ADDENDUM NO. 1
TO
CONTRACT DOCUMENTS
AND
SPECIFICATIONS
FOR
TOWN OF VESTAL
MEMORIAL POOL RENOVATIONS PROJECT

CONTRACT NO. 1 – GENERAL CONSTRUCTION
CONTRACT NO. 2 – MECHANICAL CONSTRUCTION
CONTRACT NO. 3 – PLUMBING CONSTRUCTION
CONTRACT NO. 4 – ELECTRICAL CONSTRUCTION

Sheet Number: **A600R**

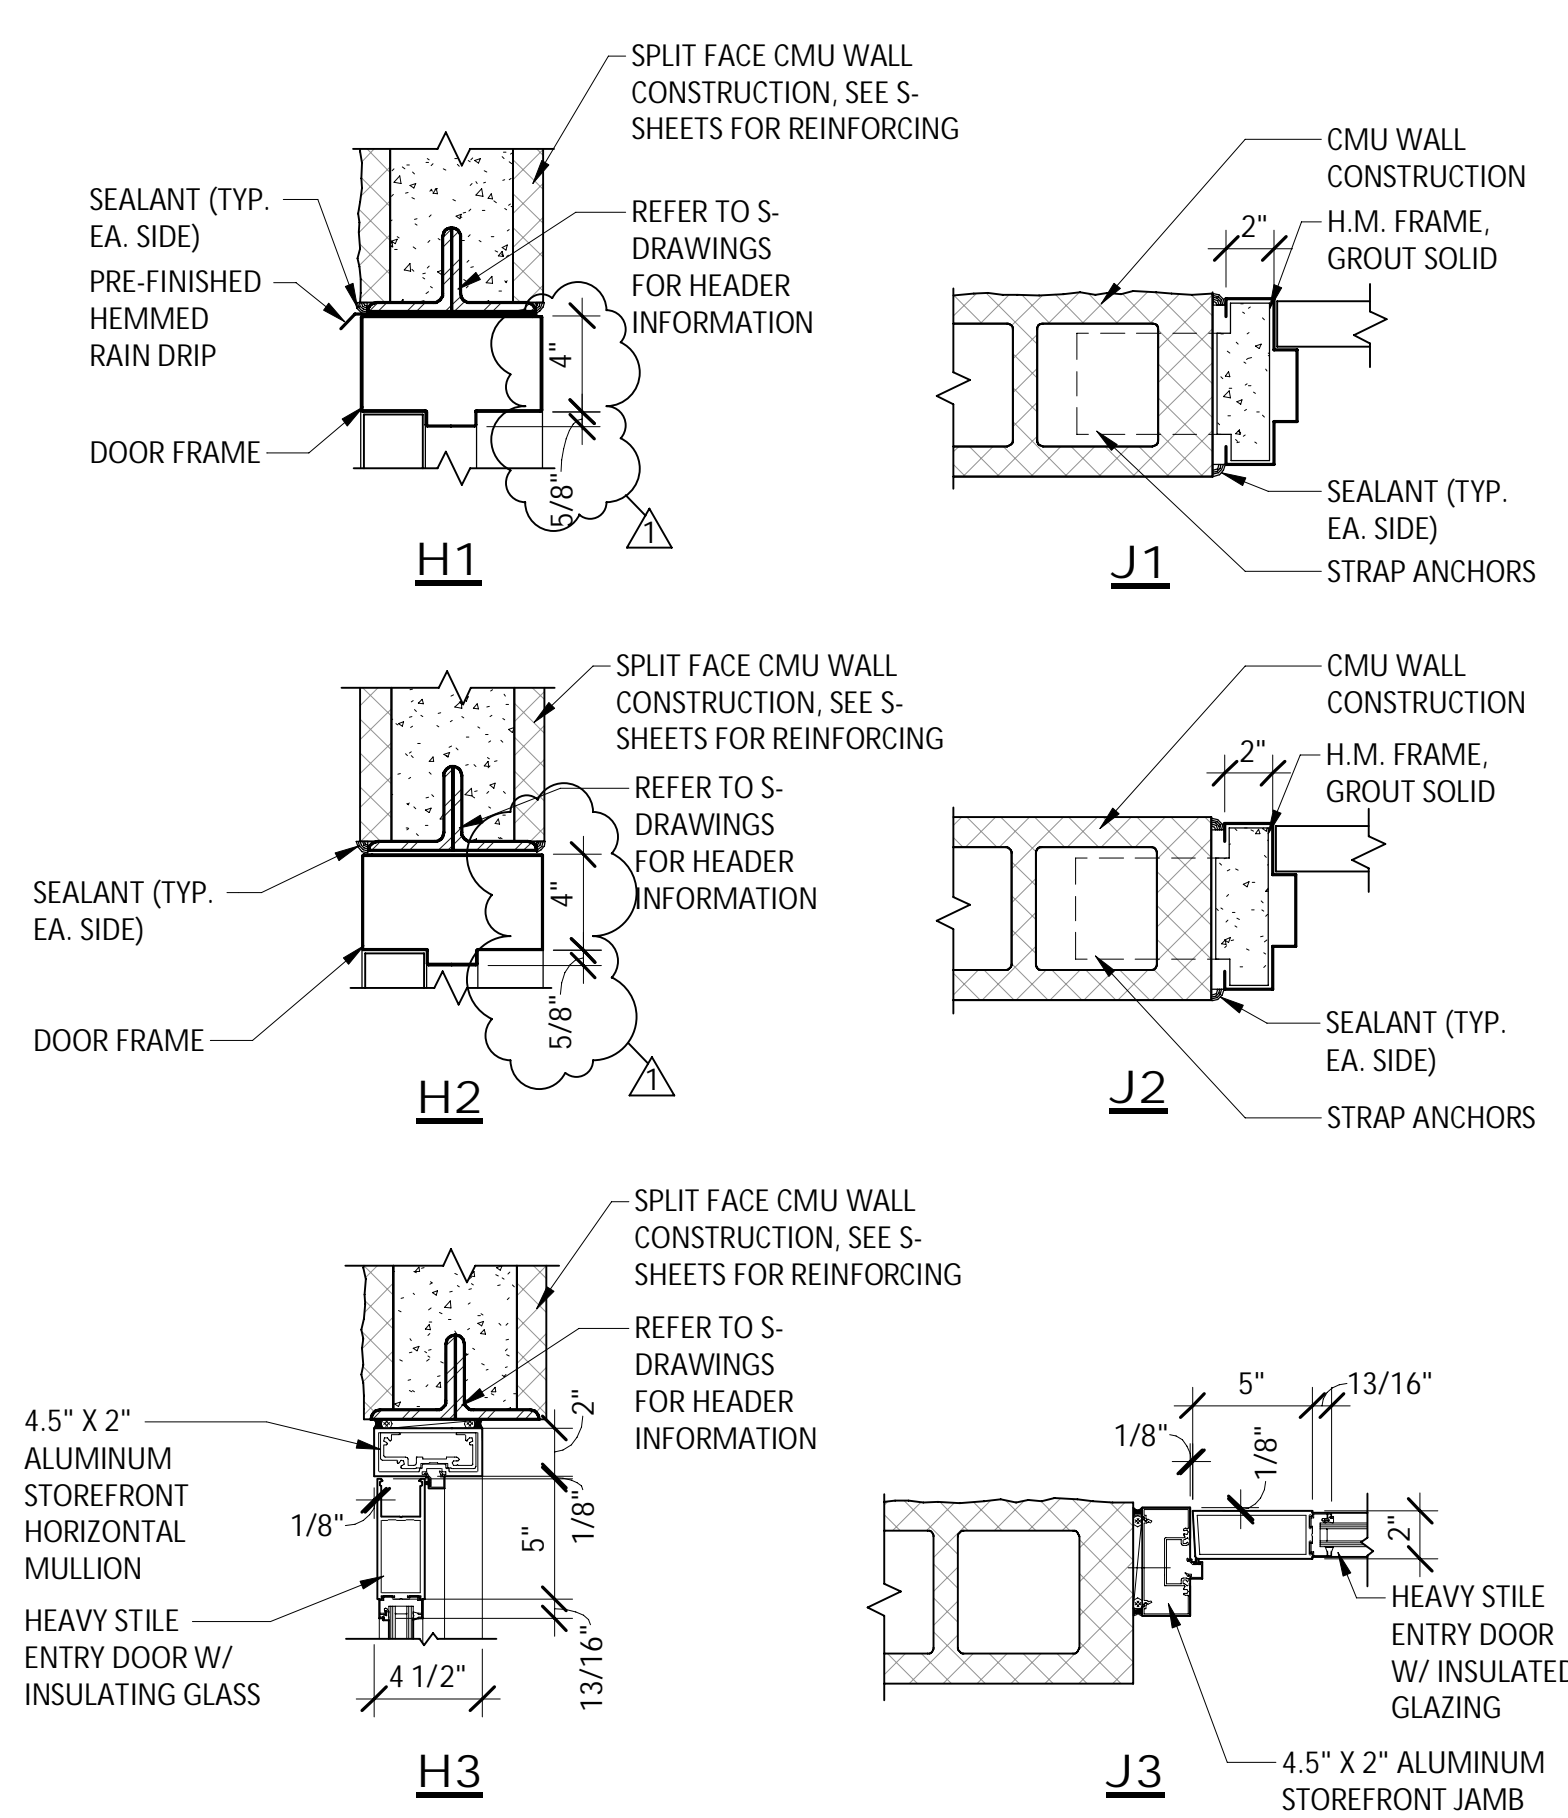
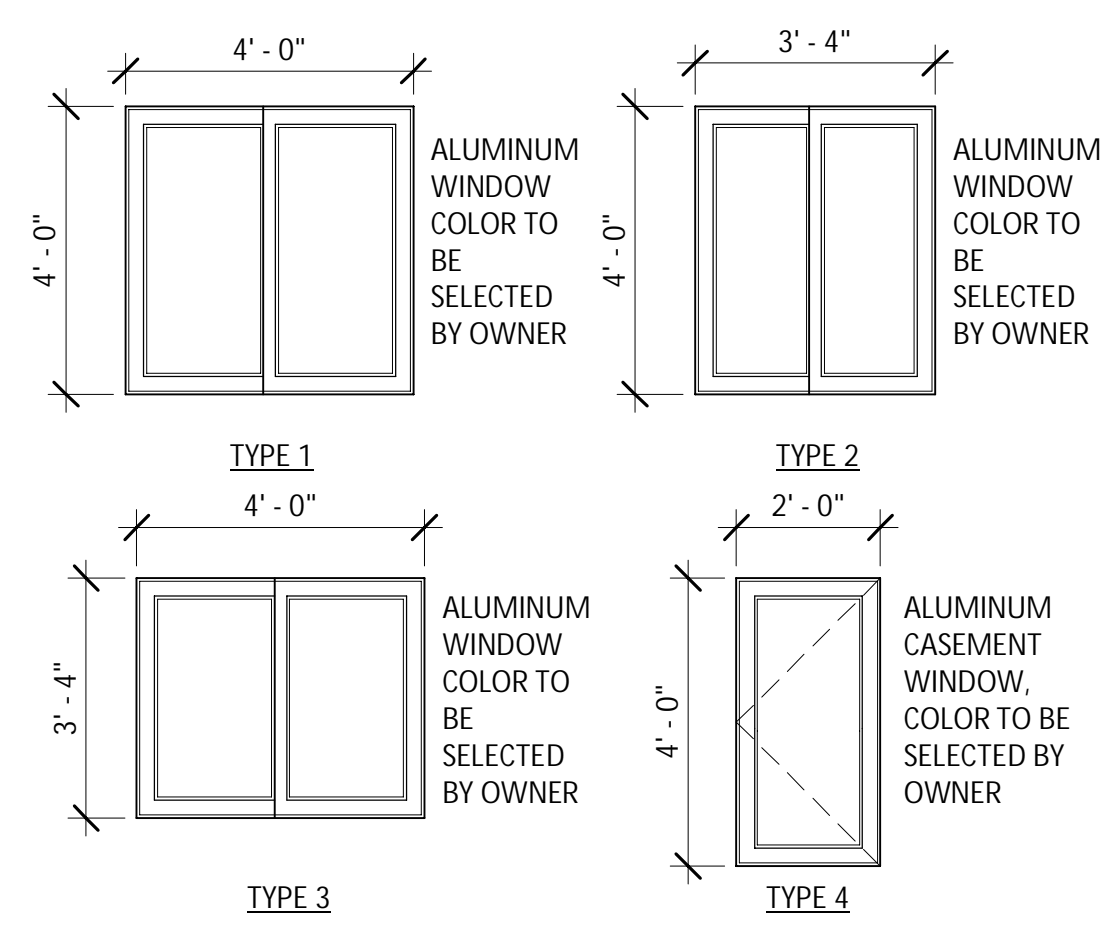
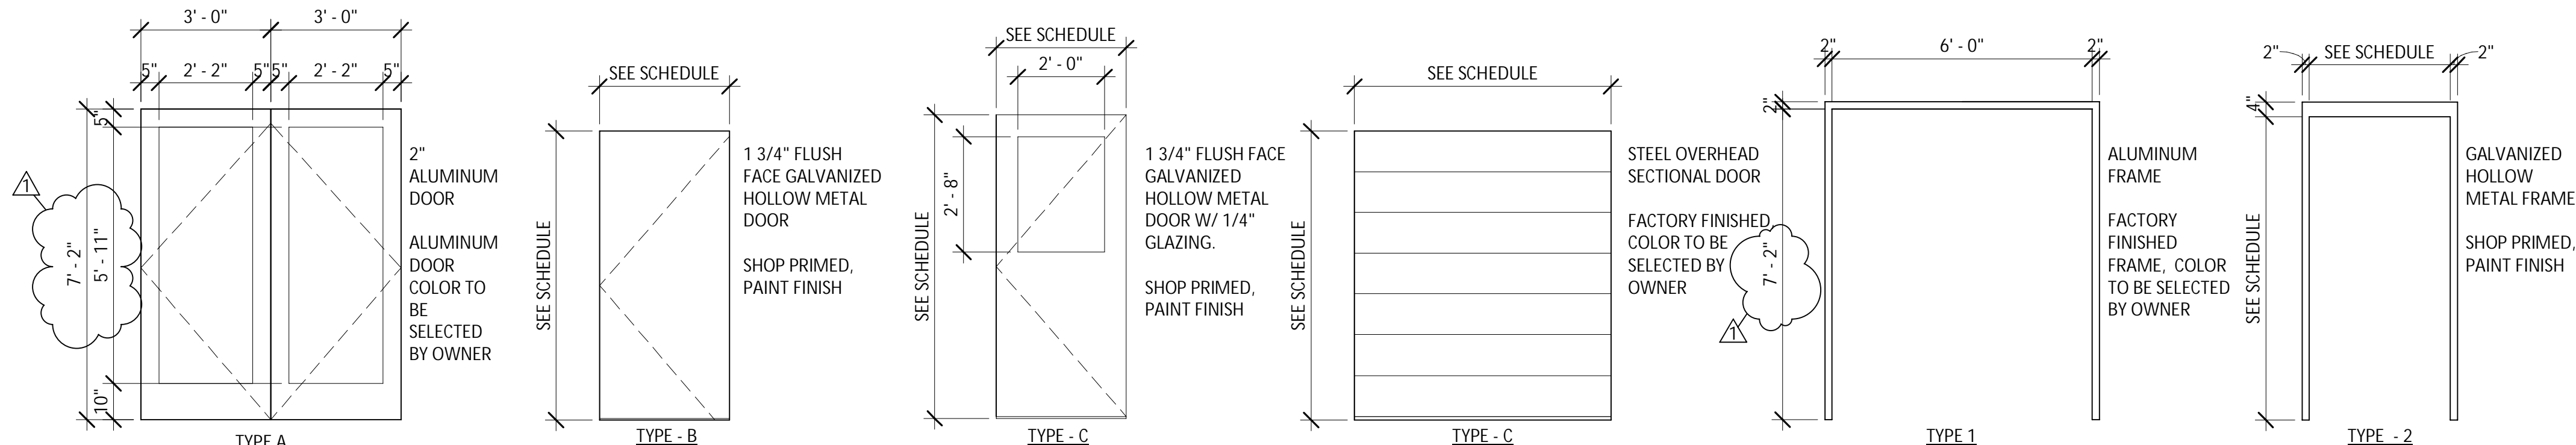
6. Reference: CONTRACT DRAWINGS – SHEET A600 – SCHEDULES AND DETAILS
- a. DELETE Sheet A600 in its entirety and SUBSTITUTE THEREFOR Sheet A600R, as attached to this Addendum No. 1.
